# CITY OF ALBUQUERQUE

RE: **1220 Iron St SW**  
**Grading and Drainage Plan**  
**Engineers Stamp Date 4/3/2018 (K13D076)**

## DRAINAGE AND TRANSPORTATION INFORMATION SHEET

SLOT HOUSE SUBDIVISION  
1220 IRON AVE. SW, ALBUQUERQUE, NEW MEXICO  
GRADING & DRAINAGE

GRADING & DRAINAGE PLAN

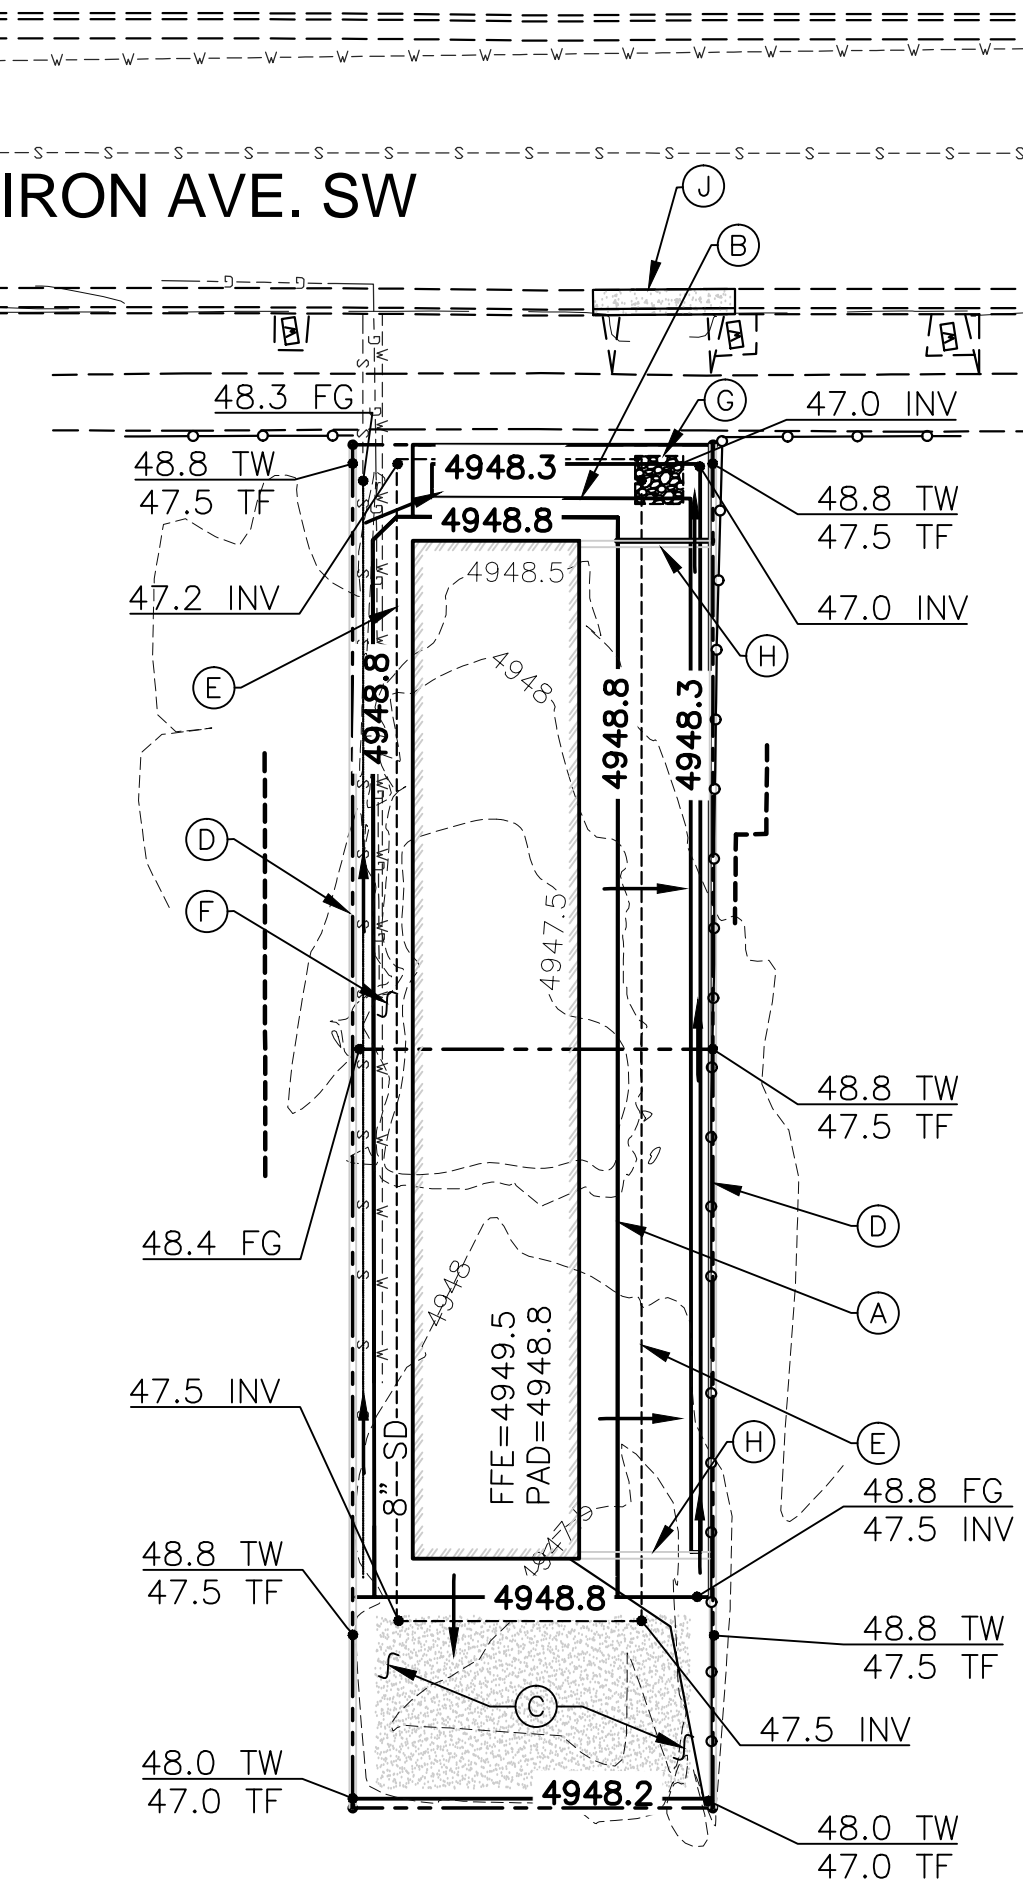
Based upon the information provided in your submittal received 5/29/2018, this plan is approved for Grading Permit and Building Permit. Please attach a copy of this approved plan and letter into the construction sets in the building permitting process prior to sign-off by Hydrology.

A Private Drainage Easement will be required on the plat with the City's standard maintenance note for the pond.

Prior to **Certificate of Occupancy release**, Engineer Certification per the DPM checklist of this plan will be required.
